APPEAL SUMMARY

Appeal ID: 23789	Project Address: 3800 SE 164th Ave
Hearing Date: 6/10/20	Appellant Name: Hayley Purdy
Case No.: B-002	Appellant Phone: 503-896-5341
Appeal Type: Building	Plans Examiner/Inspector: Alice Johnson, Thomas Ng
Project Type: commercial	Stories: 3 Occupancy: R-2 Construction Type: V-B
Building/Business Name: Centennial Place Apartments	Fire Sprinklers: Yes - Throughout
Appeal Involves: Erection of a new structure	LUR or Permit Application No.: EA #19-201053
Plan Submitted Option: pdf [File 1] [File 2] [File 3] [File 4] [File 5]	Proposed use: Multi-family

CENTENNIAL PLACE APARTMENTS

BUILDING SECTIONS

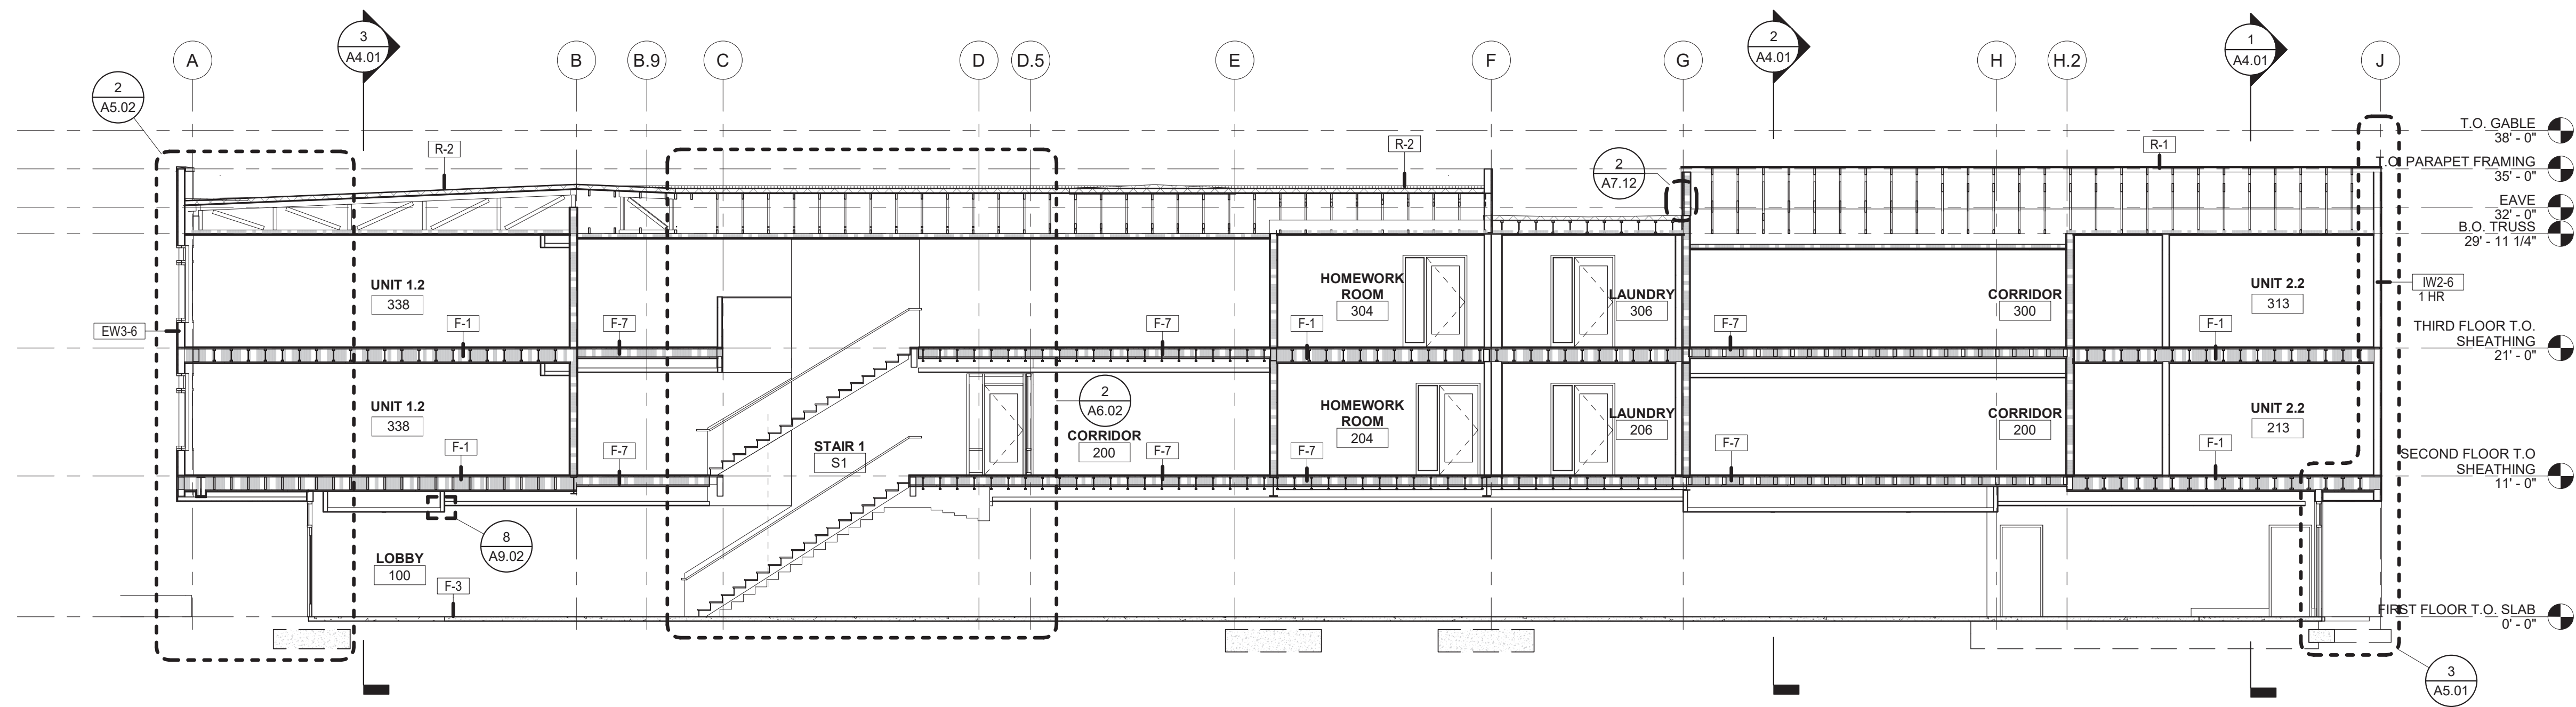
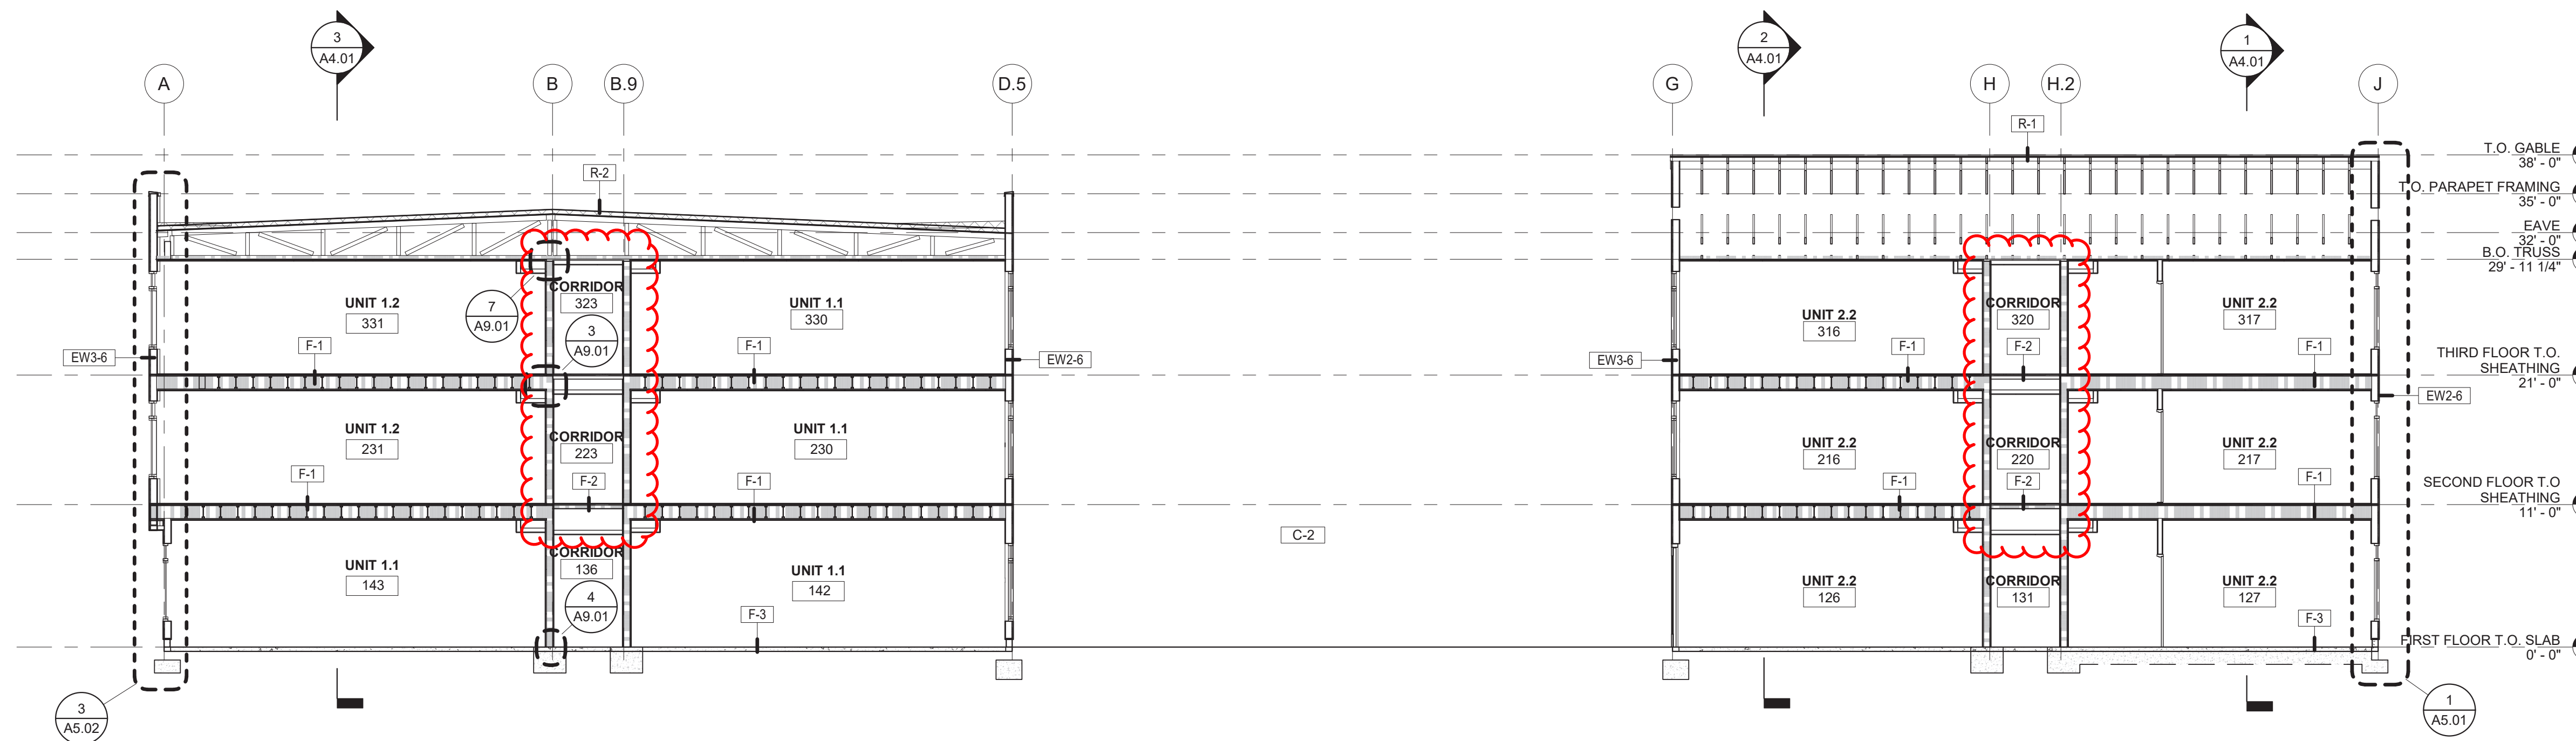
Code Modification or Alternate Requested	Approve the use of 4" decking as a 1 hour rated floor ceiling assembly according to the Building Official Determination 19-02 process.
Proposed Design	The proposed project is a new multi-family residential development located in the Centennial neighborhood on SE 164th Avenue, just north of SE Powell Blvd. Construction is fully sprinkled (NFPA 13) with 3 stories of type V-B construction. All floors are required to have a 1-HR separation. As requested in the Building Official Determination 19-02, a Char Calculation confirming fire protection of the 4" decking per 2018 NDS Technical Report No. 10 is provided by the structural engineer. The proposed 1-HR rated Corridor Floor/Ceiling, F2, includes the following layers from top to bottom: Finish Flooring per plan over ¾" Gypcrete over 1/8" Noise Control Mat over 7/8" Floor sheathing over

4" Nominal T&G Decking over
 3-1/2" Minimum mineral fiber sound batt insulation over
 5/8" Type 'X' gypsum wallboard suspended with non-combustible metal framing.

Reason for alternative This one hour rated floor/ceiling assembly F2, is required in order to provide:

We have performed a structural analysis incorporating the effects of char on the F2 assembly (located within the corridor space) indicated on sheet A0.20. The structural portion of this assembly consists of 4-in. thick nominal (actual 2 7/8" thick) Lock-Deck (glue-laminated decking) overlain with 7/8" thick plywood sheathing as indicated on sheet S2.12 and S2.13. Per the 2018 American Wood Council (AWC) Technical Report No.10 Table 4.1.1.4A, the nominal char rate is 1.5 in/hr. However, this nominal char rate is increased to a design effective char depth of 1.8 inches for a required fire resistance of one hour to account for the loss of strength and stiffness of wood directly adjacent to the char.

Based on the design effective char of 1.8 inches, an effective thickness of 1.075 inches for the 4-in. thick nominal (actual 2 7/8" thick) Lock-Deck product remains. Per the AWC Technical Report's design criteria for members with a reduced section, the 4-in. thick nominal Lock-Deck is structurally sufficient after one hour of burn time.

3. Use of 4" decking as a 1 hour rated floor ceiling assembly according to the Building Official Determination 19-02: Granted as proposed.

Note: Calculations will be verified at time of plan review.
